UNITED STATES PATENT AND TRADEMARK OFFICE

APPLICATION NO.	FILING DATE	FIRST NAMED INVENTOR	ATTORNEY DOCKET NO.	CONFIRMATION NO.
09/973,401	10/09/2001	Mark Karrs	1094-12	6080
28249	7590	11/01/2006		
DILWORTH & BARRESE, LLP 333 EARLE OVINGTON BLVD. UNIONDALE, NY 11553			EXAMINER DUONG, THANH P	
			ART UNIT 1764	PAPER NUMBER

Office Action Summary

DETAILED ACTION

Illustrated drawings

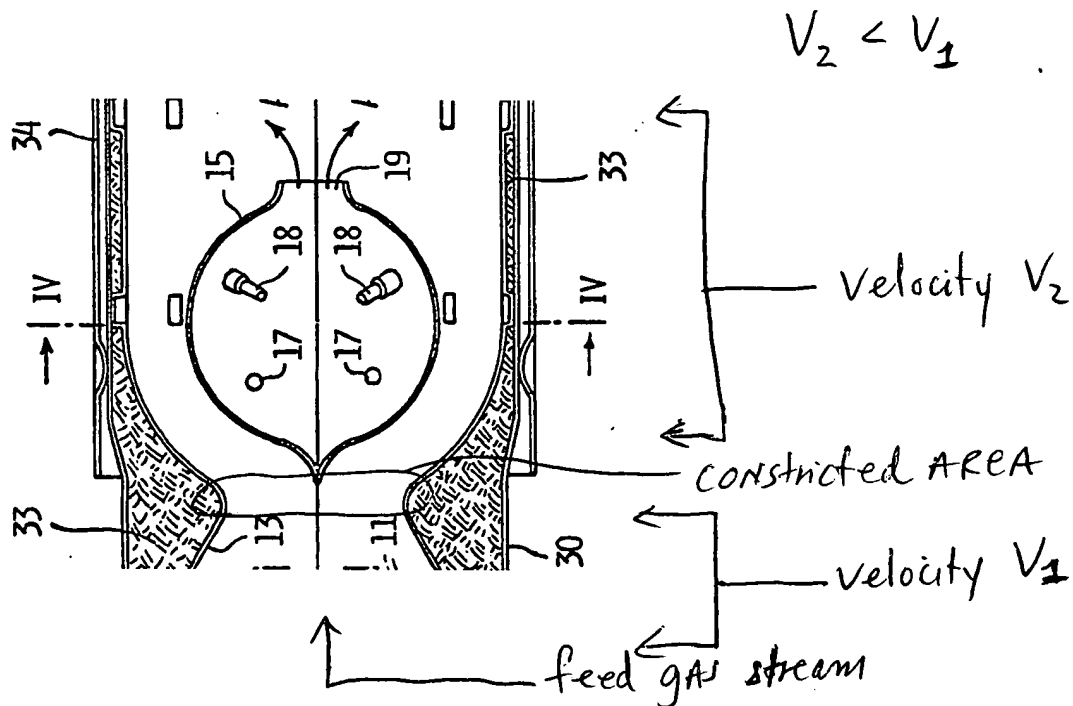
20. Claim 52 is rejected under 35 U.S.C. 103(a) as being unpatentable over the applied references (EU '480 in view of Surette '142 and Tyler et al. '846 and Ishikawa et al. '146) as applied to claims 1 and 4 above, and further in view of Zagoroff et al. (5,476,378). The applied references above fail to disclose the struts positioned in an annular space between the tail cone and the interior surface of the housing. Zagoroff teaches it is conventional to provide a shaft support struts 39 (Fig. 4) to facilitate distributing the air to the turbine blades. Thus, it would have been obvious in view of

the applied references to provide struts between the tail cone and the housing to facilitate distributing the air to the system.
